MISCELLANEOUS PAPER GL-85-2

REVIEW OF RIGID PAVEMENT DESIGN FOR VEHICULAR PARKING AREAS

20. ABSTRACT (Continue on reverse side if necessary and identify by block number) - This paper documents proposed changes to TM 5-822-6, "Rigid Pavements for Roads, Streets, Walks, and Open Storage Areas." Changes are recommended in the areas of impact effects, the coverage versus thickness relationship, and effects of high-strength subgrades. Additionally, the criteria for design thickness of vehicular parking areas should be changed to account for a differ- ent slab loading condition, including load transfer at joints. These changes establish a rational and consistent basis for CE design of rigid airfield and nonairfield pavements.-

Figure 1. Rigid pavement design curves for roads and streets

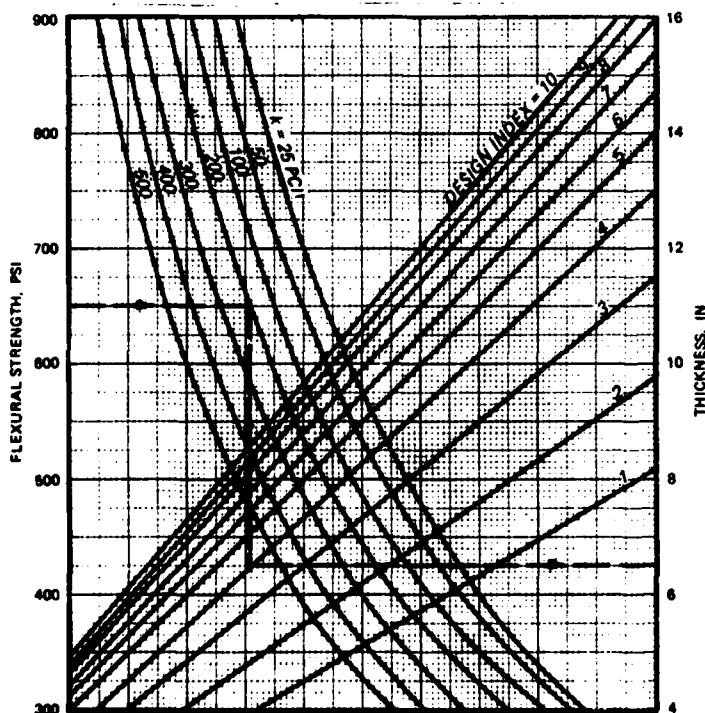
9. Current airfield pavement design includes a thickness reduction for high-strength subgrades. This reduction is based on USACE experience, and its validity is illustrated by the performance of concrete block pavements on high-strength subgrades. This same reduction (Hutchinson 1966) has been applied for roads, streets, and vehicular parking areas. The amount of thickness reduction depends upon the value of the modulus of soil reaction, k . For k values above 100 pci, the reduction in design thickness varies from zero (at $k = 200$ pci) to a maximum of 19.1 percent (at $k = 500$ pci).

10. The cumulative change in design thicknesses of roads and streets depends upon the coverage level (design index) and subgrade strength. It varies from an increase of 9 percent to a decrease of 19 percent for typical values of design parameters. The new rigid pavement design curves for roads and streets are shown in Figure 1.

Figure 2. Rigid pavement design curves for parking areas

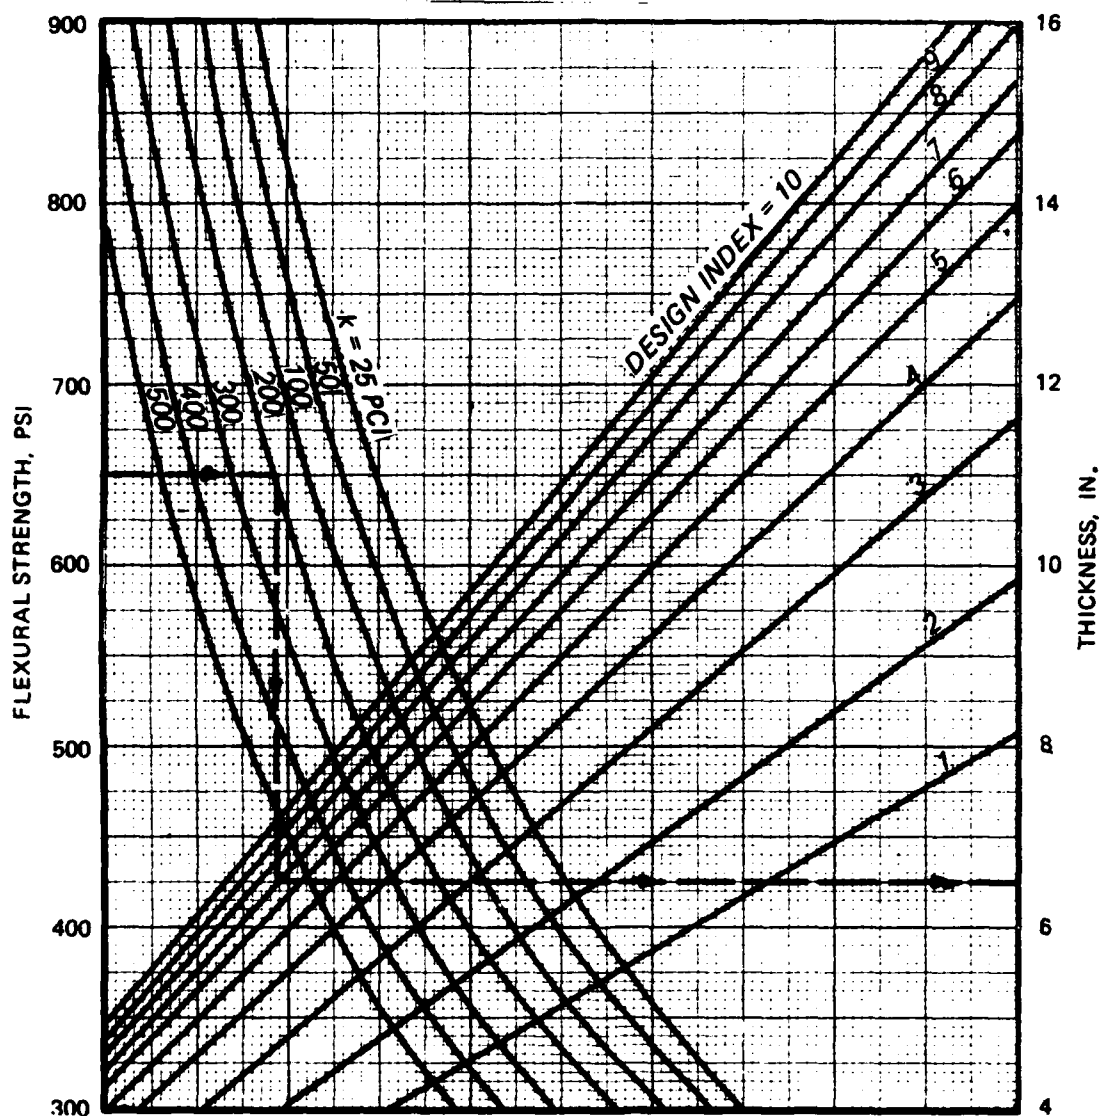
11. A survey of parking areas and traffic patterns on various military installations was conducted by the project engineer. One observation from this survey is that traffic avoids the free edges of parking lot pavements. This phenomenon is caused by curbs, fences, buildings, soft ground, etc., common along the edges of parking areas. Since the free edges are not heavily trafficked, the maximum damage to parking lot pavements results from stresses caused by traffic loads along interior joints rather than along free edges. These interior joints are load transfer joints. A 25 percent load transfer is used for interior joints of airfield pavements (Parker et al. 1979). Therefore, the maximum design stresses in parking lot pavements can be estimated at 75 percent of the free edge stresses. Using these reduced stresses allows a design thickness reduction of about 17 percent.

13. The cumulative decrease in parking area design thickness, depending upon coverage level and subgrade strength, is 12 to 27 percent for typical values of design parameters. The new rigid pavement design curves for vehicular parking areas are shown in Figure 2.
